Balboa Park  
Central Mesa Precise Plan  
Plan Amendments

**PLAN AMENDMENTS**

**THIRD DRAFT**  
**May 2003**

Prepared by:  
MacLeod Consulting Services, LLC  
Estrada Land Planning, Inc.

**LAND USE SUMMARY**

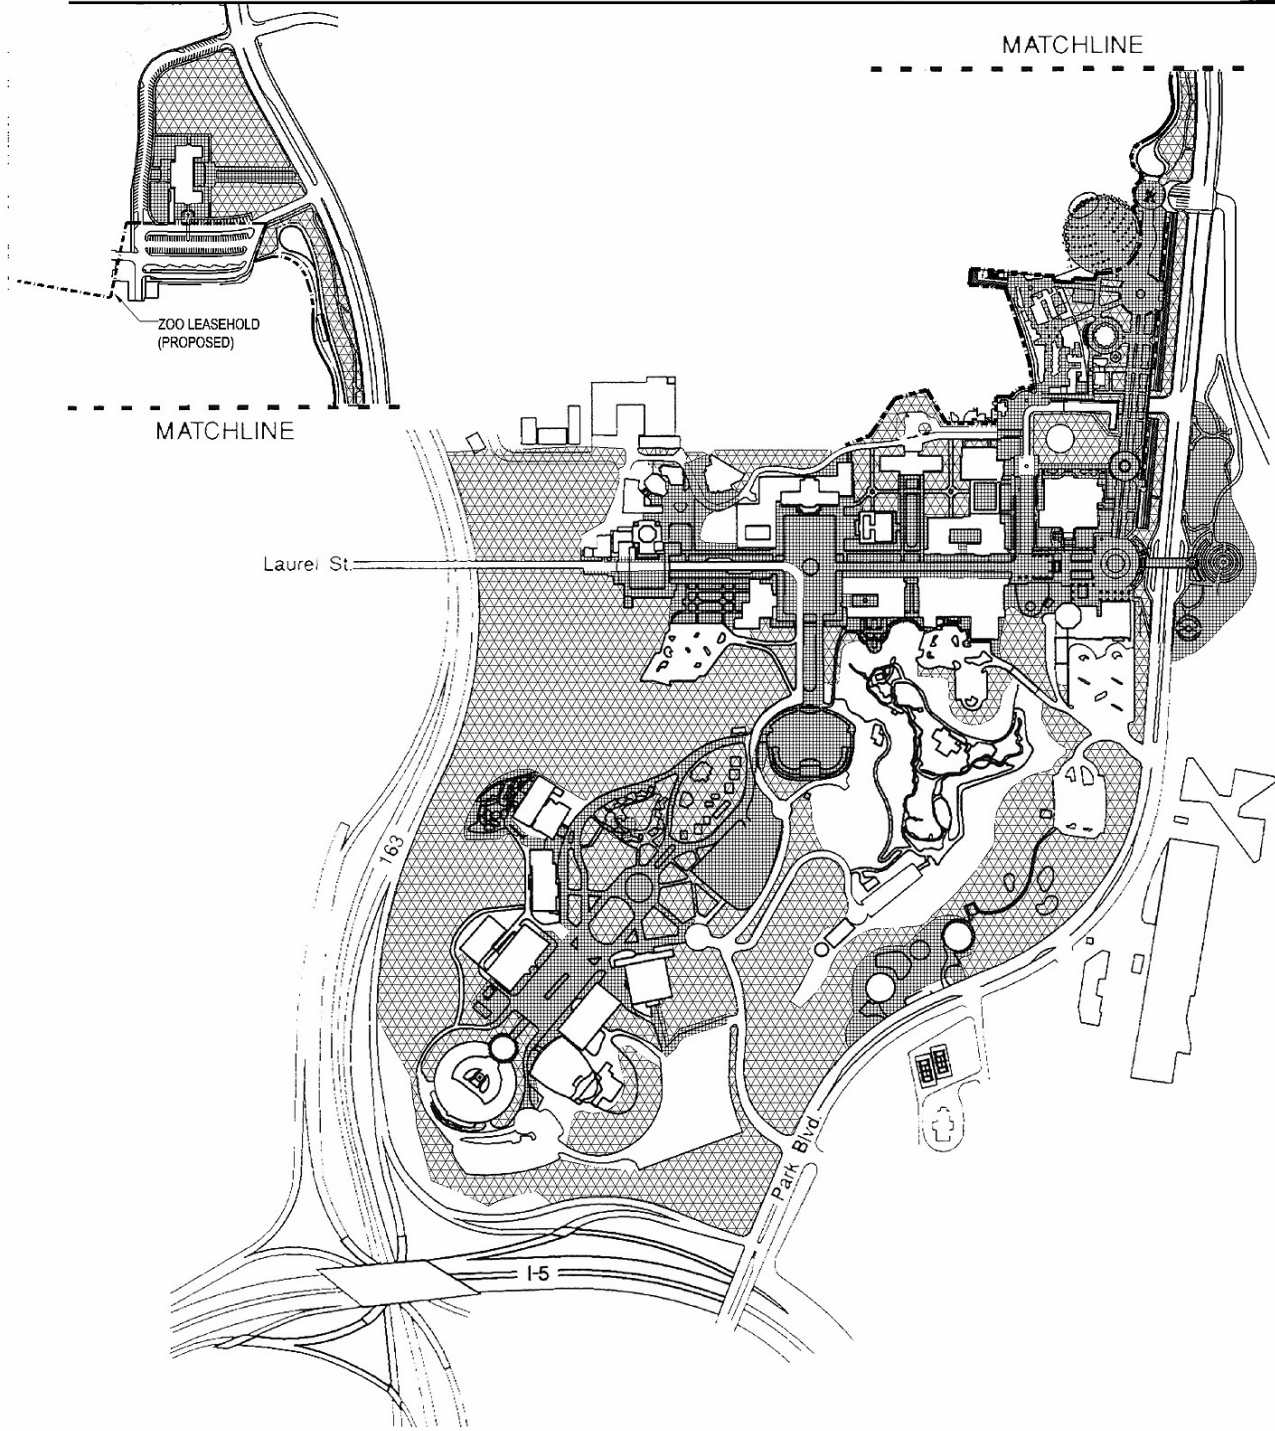
<b>LAND USE (in acres)</b>	<b>EXISTING</b>	<b>PROPOSED</b>	<b>CHANGE</b>
Open Public Park Land	89	<del>111</del> 116	+22 +27
Restricted Use Areas	33	19	-14
Roads and Parking Areas	54	<del>45</del> 21	-9 -33
Buildings	17	18	+1

PROPOSED 2010 PARKING SUPPLY, ~~JUNE 1991~~.

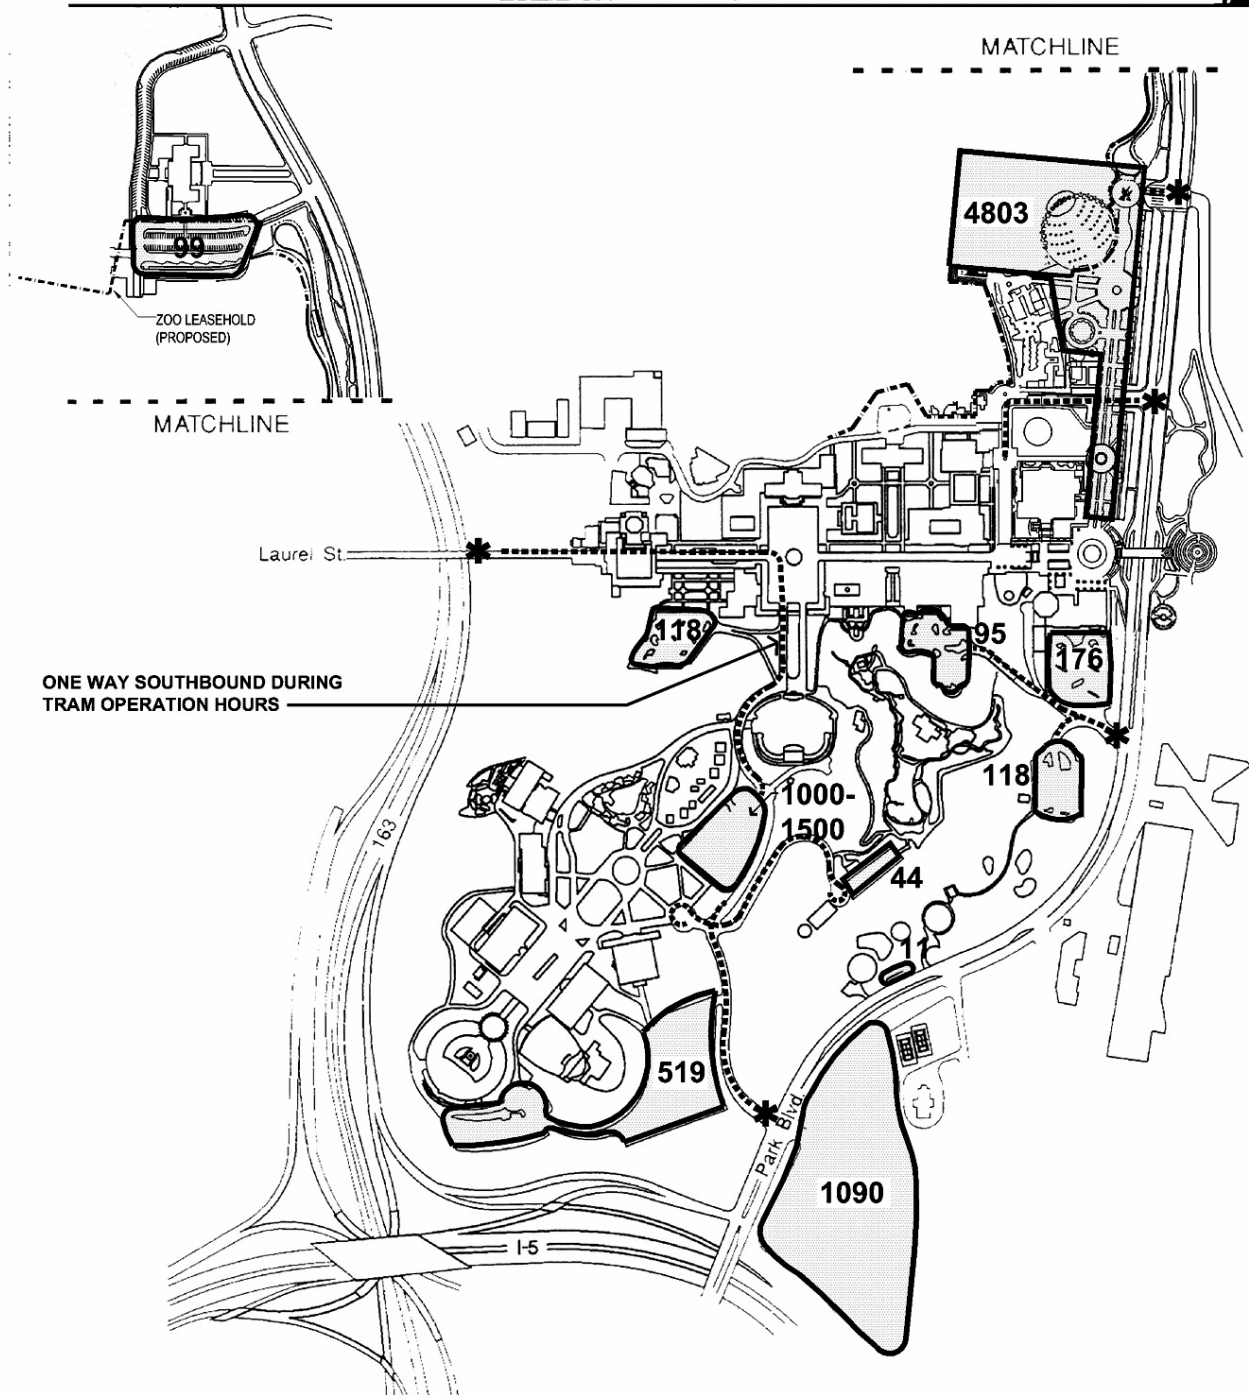
PARKING LOT:	NUMBER OF SPACES		
	(1)	(2)	(3)
ZOO <u>EMPLOYEE</u> LOT	3,016	<del>2,831</del>	450
NORTH CAROUSEL LOT	91	<del>103</del>	0
SOUTH CAROUSEL LOT	234	<del>215</del>	0
NATURAL HISTORY MUSEUM LOT	102	<del>101</del>	0
ALCAZAR GARDEN LOT	137	118	118
CASA DE BALBOA LOT	119	95	95
FLEET SPACE THEATER LOT	167	176	176
PEPPER GROVE LOT	125	118	118
ORGAN PAVILION PARKING GARAGE			**1,000-1,500
FEDERAL/AEROSPACE LOT	<del>531</del>	519	519
GOLD GULCH LOT	38	44	44
CENTRO/WORLDBEAT LOT			11
<u>WAR MEMORIAL LOT</u>			99
<u>PARK BOULEVARD PROMENADE</u> <u>STRUCTURE</u>			4,803
SUBTOTAL:	<del>5,571-6,071</del>	<del>5320-5820</del>	7433 - 7933
ZOO <del>PLACE</del> <u>DRIVE</u> PARKING SPACES	120+	93	74
PARK BOULEVARD PARKING SPACES	340+	<del>225</del>	201***
SUB-TOTAL:	460+	318	275
INSPIRATION POINT LOTS	1,232	<del>1090</del>	1090
<u>TOTAL PARKING SPACES:</u>	<del>7,263-7,763+</del>	<del>6728-7228</del>	8,798-9,298

Note: The number of parking spaces in Central Mesa parking lots has changed over the years due to re-striping. This table has been modified accordingly.
